MILITARY SPECIFICATION

CONVERTER, LIQUID OXYGEN GCU-10/A

This amendment forms a part of Military Specification MIL-C-25974D, dated 1 April 1983 and is approved for use by the Department of the Air Force, and is available for use by all Departments and Agencies of the Department of Defense.

FIGURE 5. Schematic diagram of converter with capacitance gaging element.

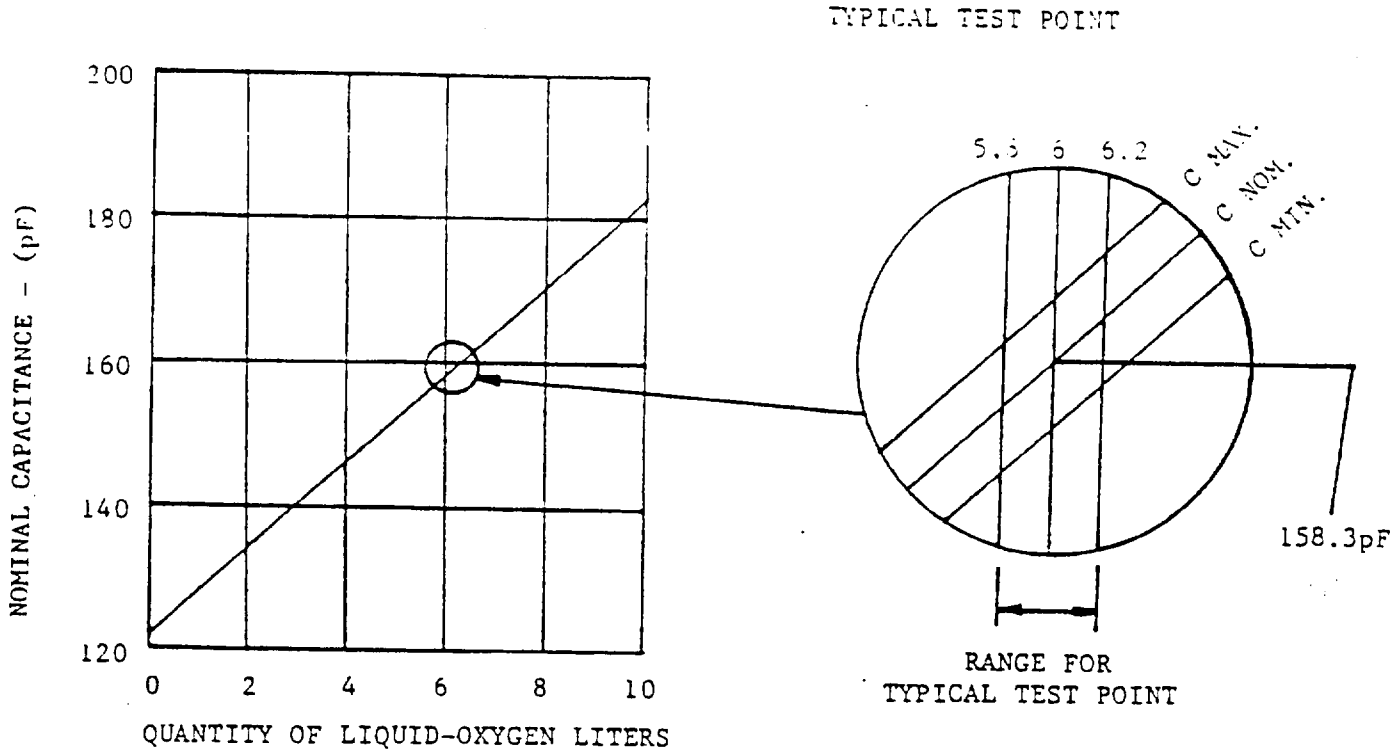
3.3.1: Delete entirely and substitute the following:

"3.3.1 Schematic diagram. The converter shall be designed in accordance with the schematic diagram shown in figure 5."
